RE: MINOR CHANGE UPON LAND AT 255 & 261 BEENLEIGH ROAD, SUNNYBANK (COUNCIL REFERENCE A006894889)

We write in relation to the abovementioned application and Council's Further Advice dated 23 January 2026.

Figure 1: Bulk bin enclosure stage 1

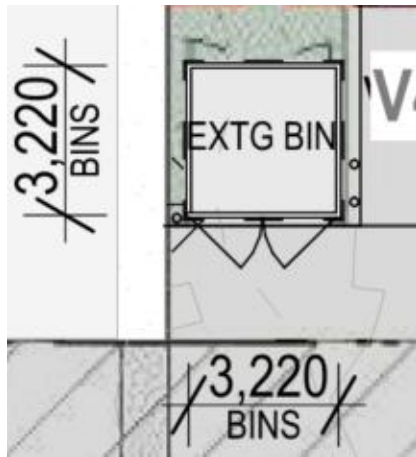
- a) *The refuse storage enclosures are to be amended to have internal dimensions of 2.7 metres by 3.0 metres and an internal height of 2.1 metres and are to be clearly dimensioned and to scale on the plans.*

- a) The amended refuse storage enclosures have internal measurements as follows;
 - Stage 1 - 3220mm x 3220mm
 - Stage 3 - 4170mm x 3520mm

This surpasses the minimum dimensions as suggested by Council as part of the above RFI item. Please refer to update Architectural plans prepared by *Ultralinea Architecture* attached for details.

Figure 3: Updated Staging 1 Boundary

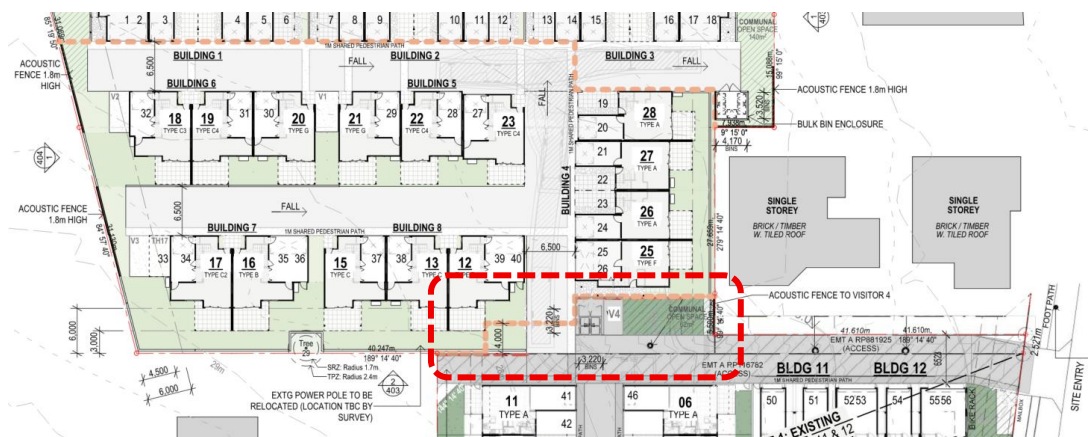
- d) *The stage boundary between Stage 1 and Stage 2 has been changed from the previously approved GIA (11 May, 2022) and does not allow an RCV to manoeuvre and turn around entirely in Stage 1 prior to Stage 2 being constructed. The stage boundary between Stage 1 and Stage 2 must be amended to allow an RCV to manoeuvre and turn around entirely in Stage 1 prior to Stage 2 being constructed and this must be demonstrated with a RPEQ endorsed swept path.*

- d) The staging boundary has been updated in response to the above RFI item and is shown on the Updated Architectural Plans prepared by *Ultralinea Architecture*. Refer to the attached plans for details.
